**Consultation response on Transport for London plans for a new North-South Superhighway****1. Introduction**

London Cycling Campaign is the capital's leading cycling organisation with more than 12,000 members and 40,000 supporters. We welcome the opportunity to comment on proposals for the new North-South cycle superhighway.

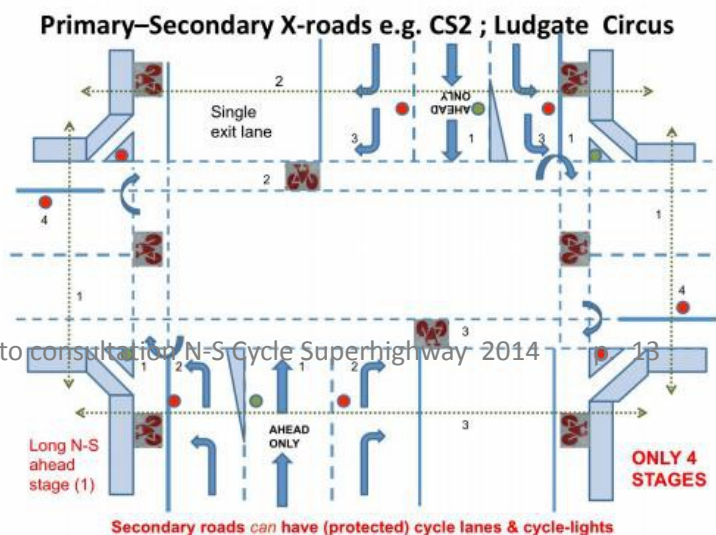
Comments:

a. This means that N-S drivers get three green stages but cyclists only get one.

b. The service for cycles here and elsewhere on this CSH is inferior to that which TFL is providing at other major junctions by "Hold the left turn" in which cycles can GO straight ahead during the entire straight ahead stage for motors, and pedestrians can cross straight over in a single stage;

c. Just because there is not space to separate Left/Ahead/Right-only traffic on the minor roads does not mean that safe cycle facilities can't be provided. Cycles must be provided with protection from left hooks and facilities for two-stage right turns on all four arms of the junction – there should be no ASLs.

d. Left turning cycles should have a left filter before the lights.

### LCC's proposal - see the diagram

On the primary roads (New Bridge Street/Farringdon St):

- Implement 'hold the left turn' for N-S traffic as per other major jcts (Stage 1) but note that the turning stage is different – see below
- Take out all the pedestrian islands and re-allocate the space to narrow signal (only) islands. Note : pedestrian islands are NOT needed. Pedestrians will have ample time to cross straight over the two secondary roads in a single stage and we believe they should also have time to cross over the primary roads at Ludgate Circus in a single stage.

- On the secondary roads (Fleet Street and Ludgate Hill) implement LCC's new major-minor junction design that prevents left hooks for cycles on all 4 arms by providing a separate cycle-light and upgrading the kerbside cycle lane (lighter protection will suffice e.g. armadillos / wands).

- In Stage 2 left and right turning motors from one primary road only (not both)
  - e.g. N-bd share the same green phase with cycles from one secondary road only (not both)

- e.g. E-bd who can now GO straight ahead safely at the same time because there is no conflict with the turning motors from the primary road on their right (so can parallel E-W pedestrians)

- In Stage 3 S-bd left & right turners time-share with W-bd cycles going straight ahead and pedestrians (E-W). Then in stage 4 the motors (only) on the two secondary roads share the same green, as now, but without the current conflict with VRUs.

*In this proposal cycle turning movements are as follows:*

- Left turns: as shown in the diagram, cycles have a filter on all four arms
- Right turns: these are carried out in two stages, e.g. in stage 1, NB cycles wait by the triangular refuge until EB cycles get a green signal.

LCC Signal Stages for the Fleet Street–Ludgate Circus junction:

1. NB and SB straight ahead only for all modes; pedestrians across Fleet Street and Ludgate Hill. NB and SB cycles move to the corresponding waiting area for a 2-phase right turn into Ludgate Hill or Fleet Street respectively. To facilitate these turns and to provide waiting space, the segregation needs to be made shorter.
2. NB motors turn left and right; EB cycles straight ahead only; pedestrians cross Farringdon Street (E-W)
3. SB motors turn left and right; WB cycles straight ahead only; peds cross New Bridge Street (E-W)
4. EB and WB motors (only) all directions (not cycles nor peds).
